Addendum No. 1

RE: Contract # C205036

Robeson County (U-5797)

SR-1997 (FAYETTEVILLE RD) FROM FARRINGDOM ST TO EAST 22ND ST

-Y2- (NC 211 / ROBERTS AVE.)
-Y3- (BOOMERANG DR.)

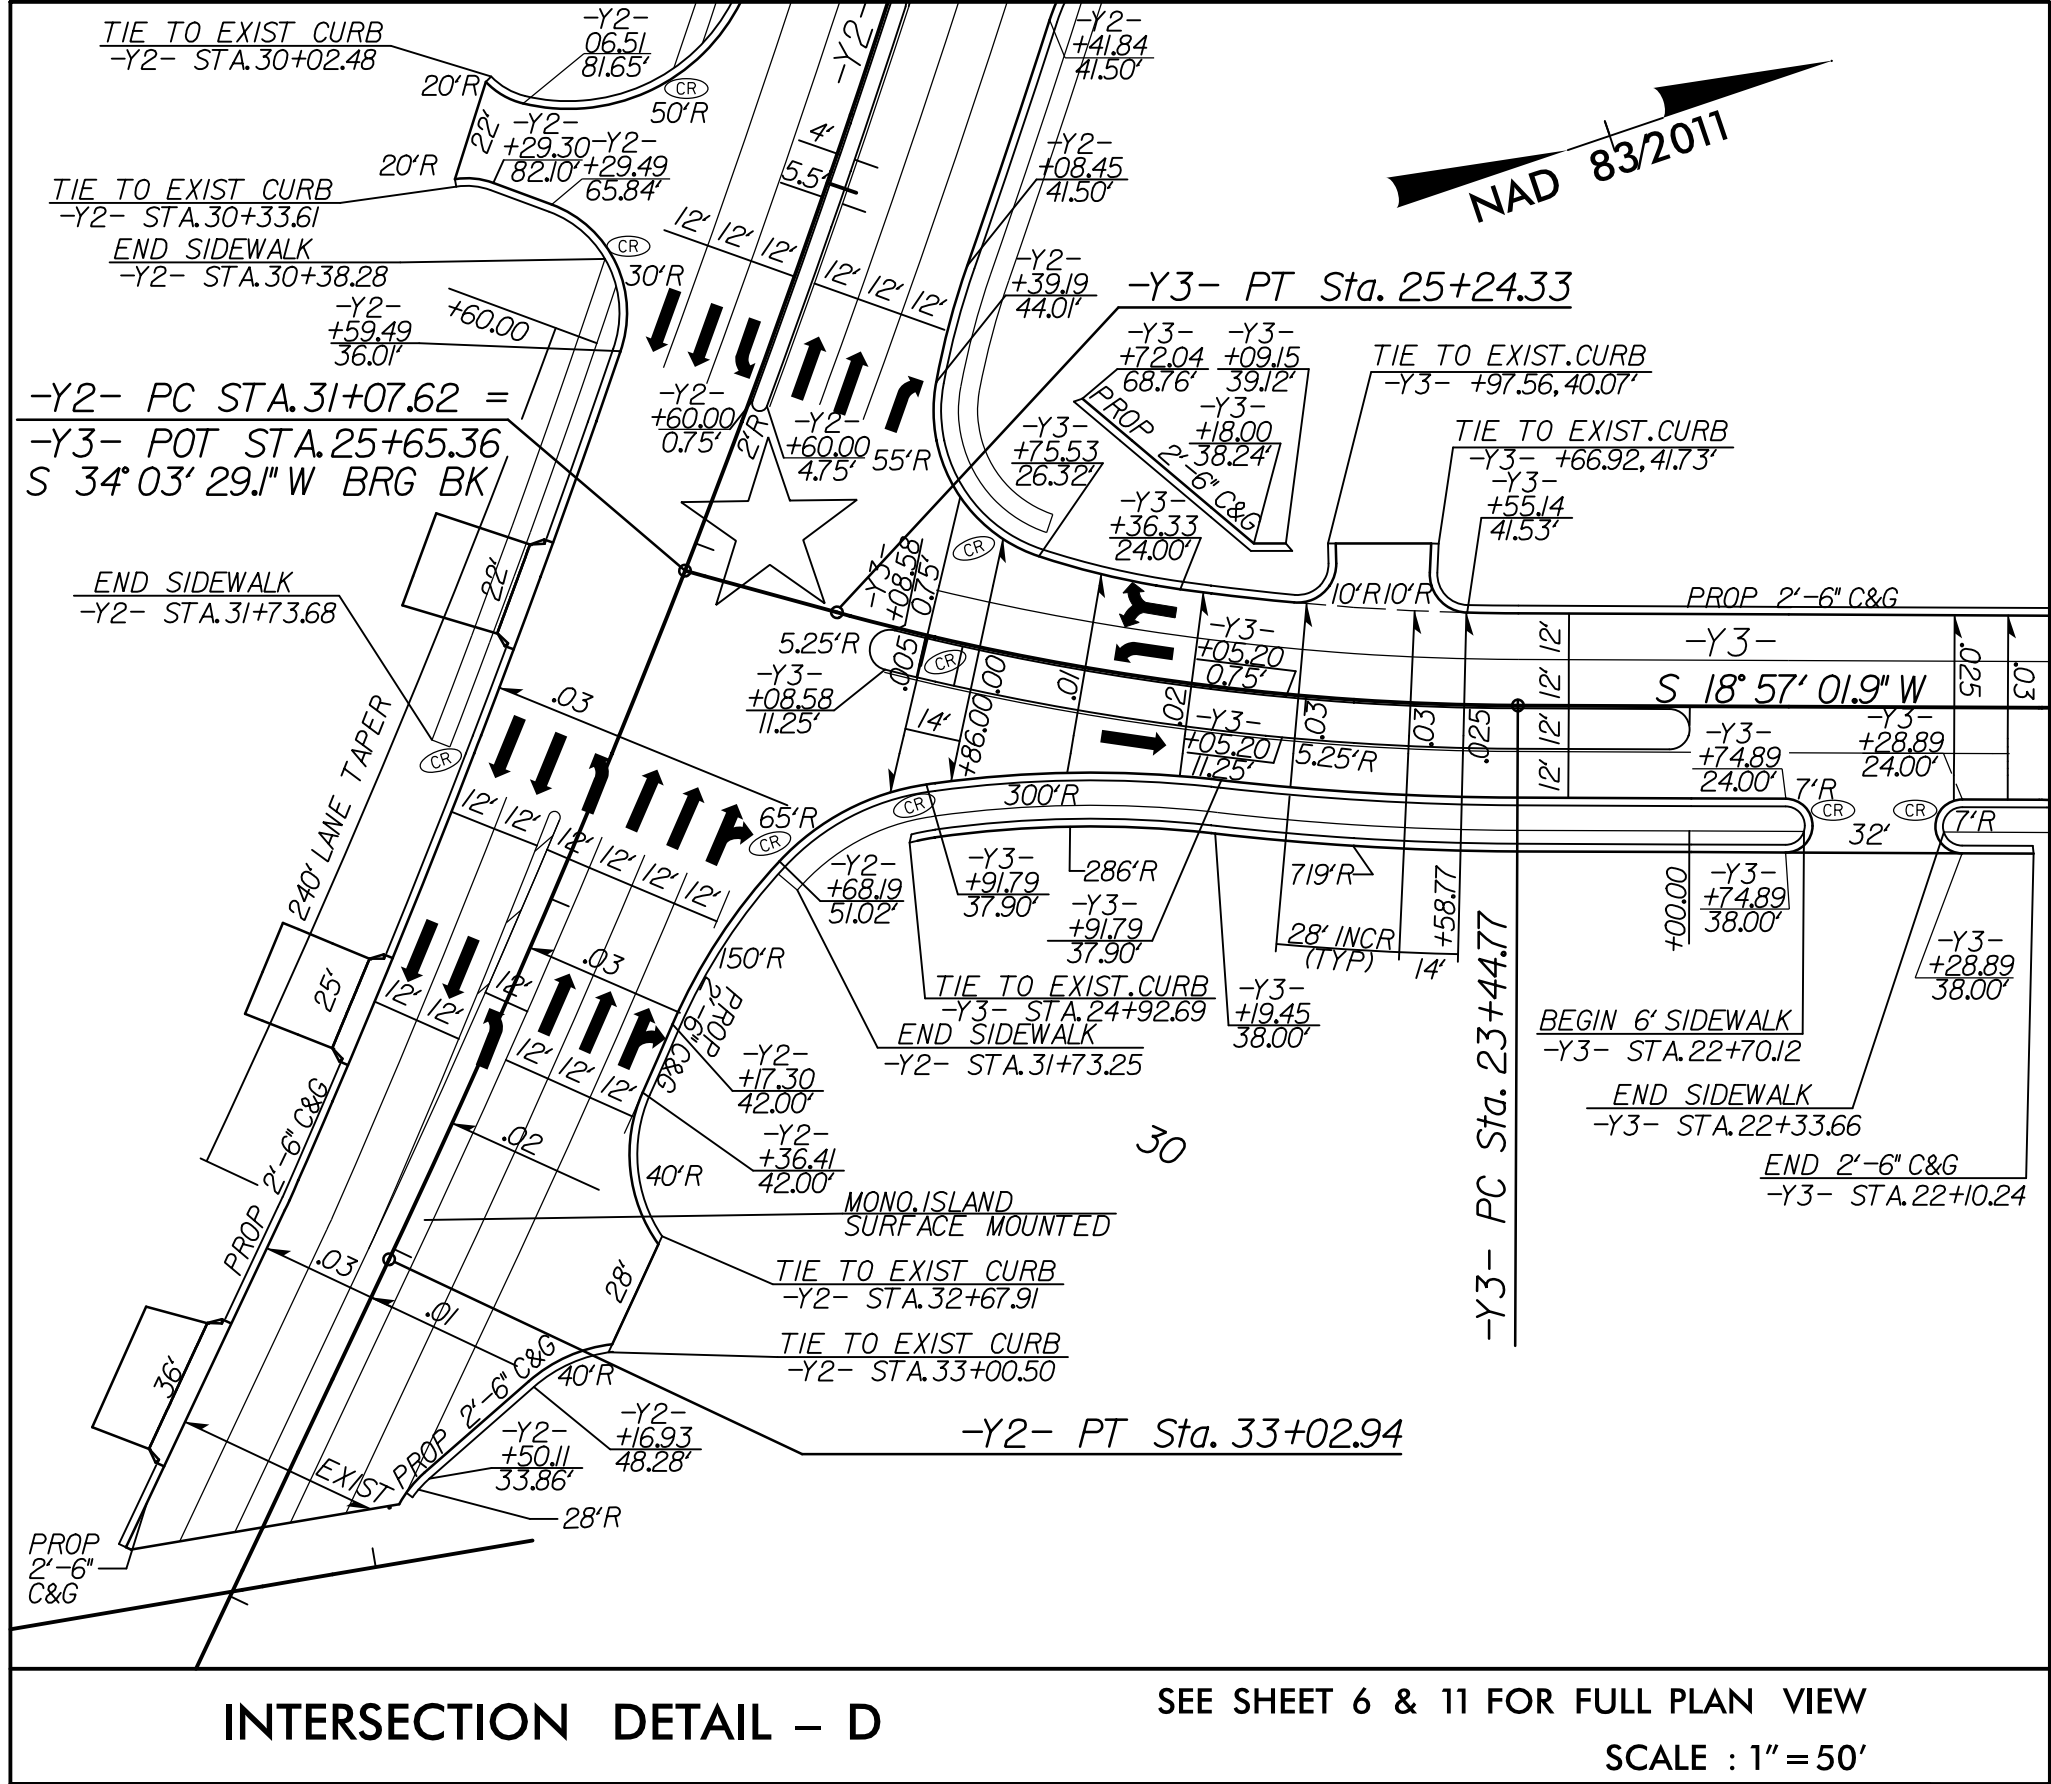
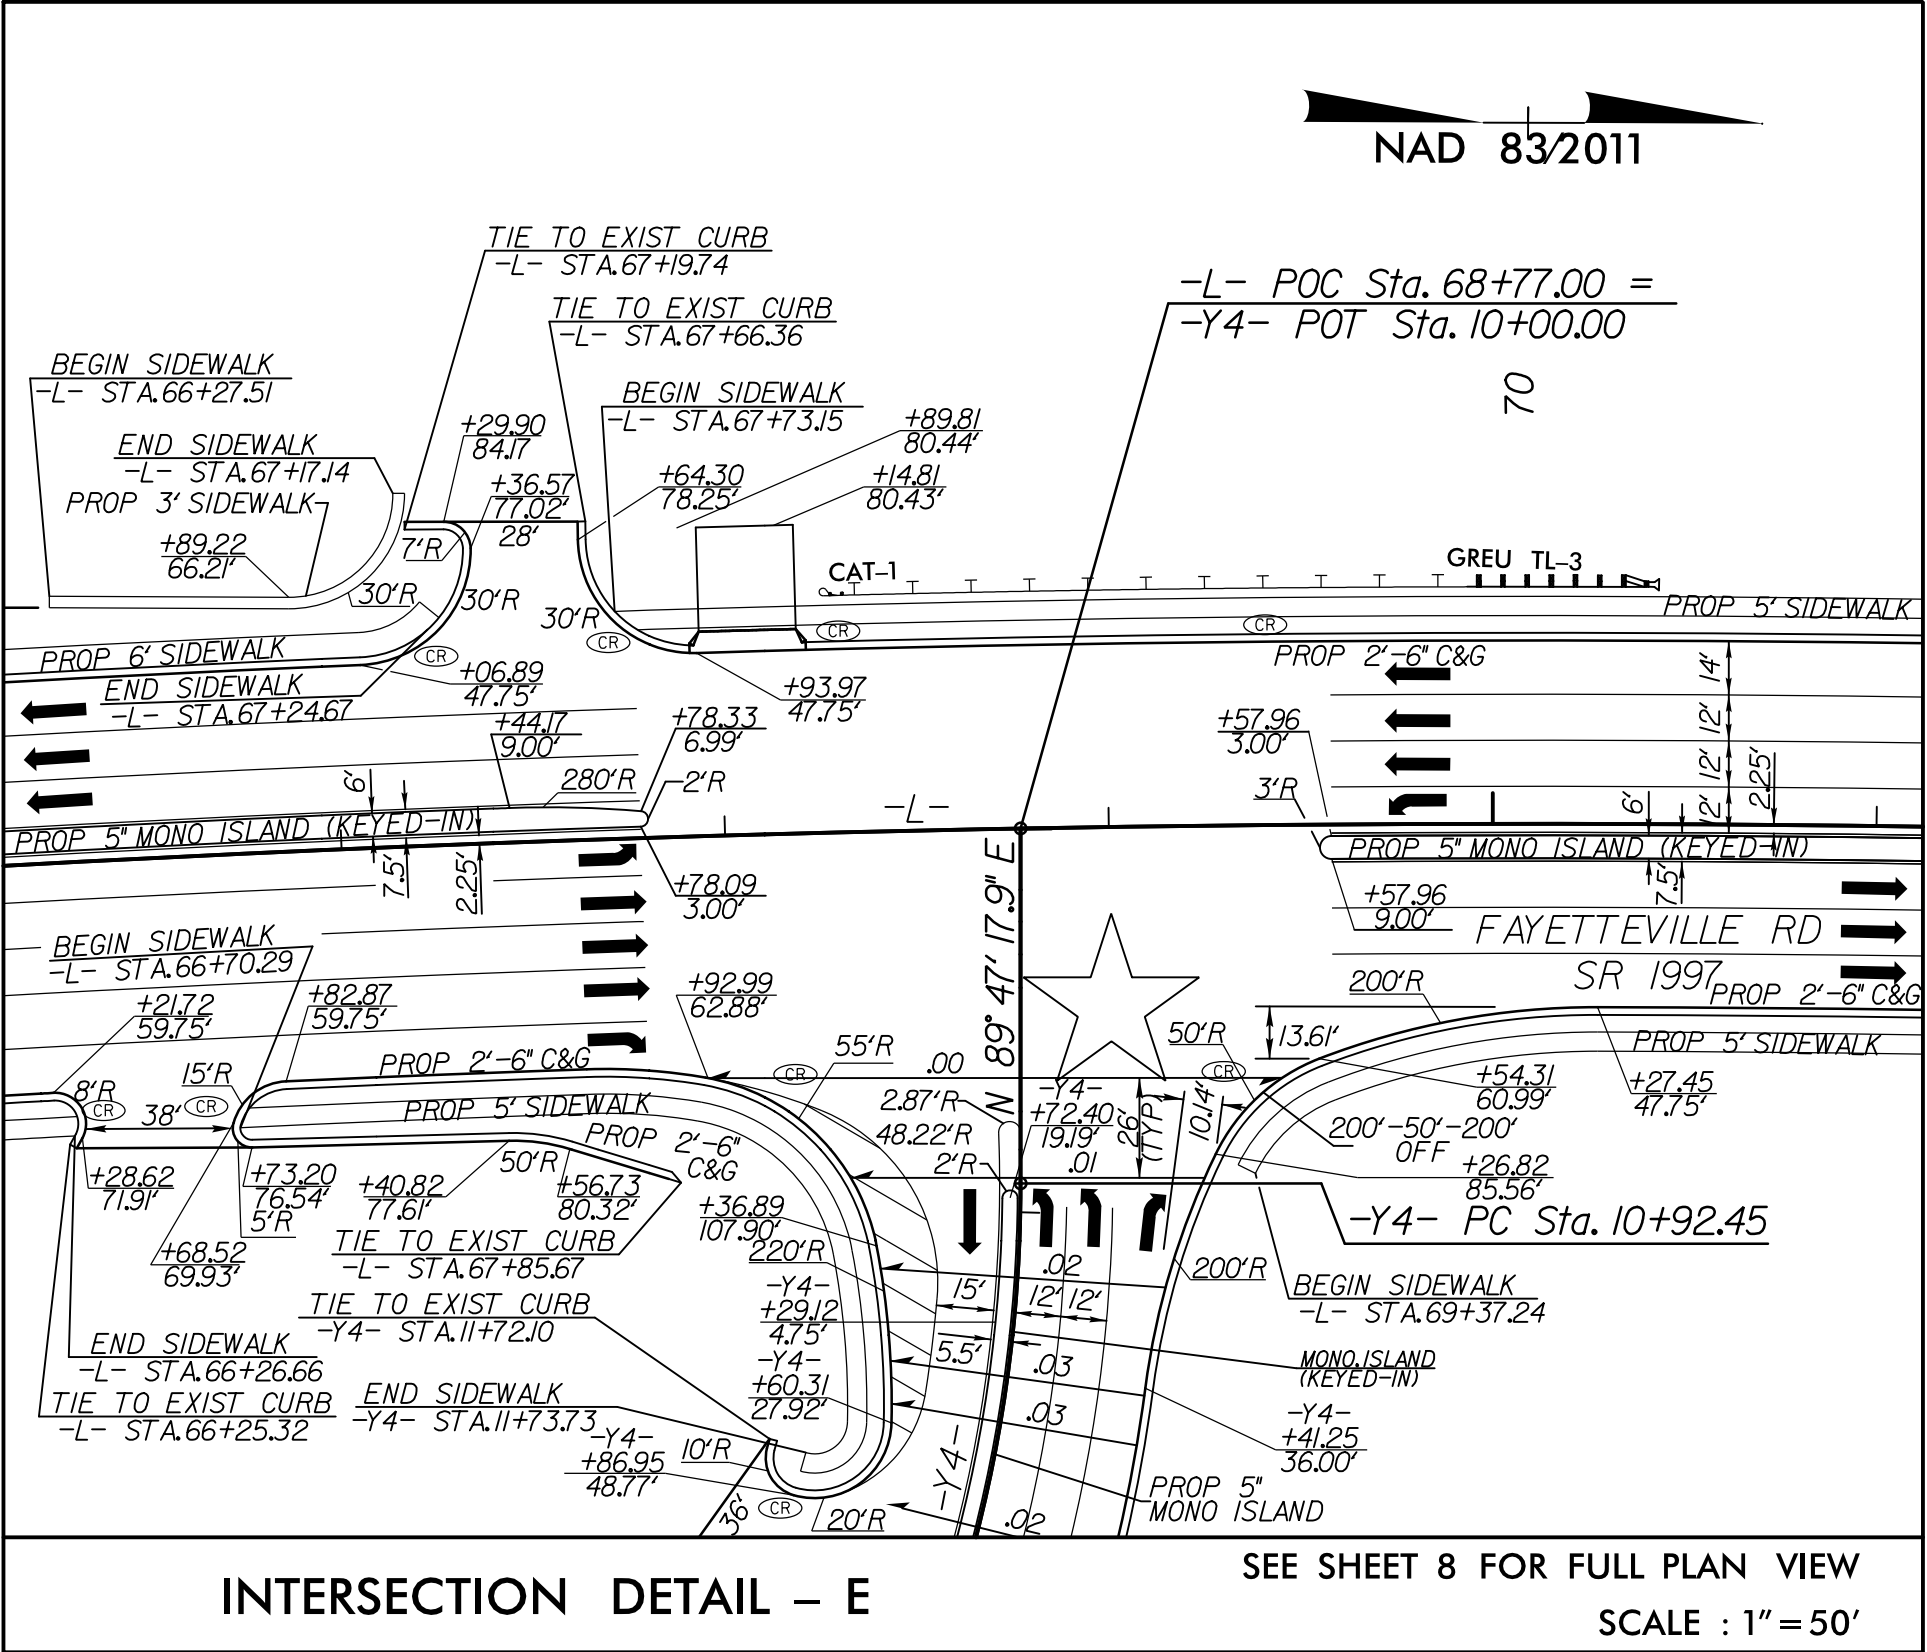
2B-2	Updated Intersection Detail D to match updated design
2B-3	Deleted the Roberts RR crossing from this sheet. Island shortened to be outside of Railroad ROW
2B-6	Deleted the Roberts RR crossing from this sheet. Island shortened to be outside of Railroad ROW
3B-1	Earthwork Updated for Y2 updates
3B-2	Pavement Removal Summary Updated
3D-11	• 1101 Box removed • 1101-1100 pipe removed • 1102 box removed • 1102-1101 pipe removed • 1103 box removed • 1103-1101 pipe removed • 1104 box removed • 1104-1101 pipe removed • 1105 box removed • 1105-1104 pipe removed • 1106 box removed • 1106-1105 pipe removed 1110 through 1114 pipes and boxes moved from sheet 3D-12 to sheet 3D-11
3D-12	• 1107 box removed • 1107-1104 pipe removed • 1108 box removed • 1108-1104 pipe removed • 1109 box removed • 1109-0674 pipe removed Lines shifting up
3D-13	• Y2 36+37 Flowable fill removed • Y2 35+57 and Y2 34+71 pipe removal removed
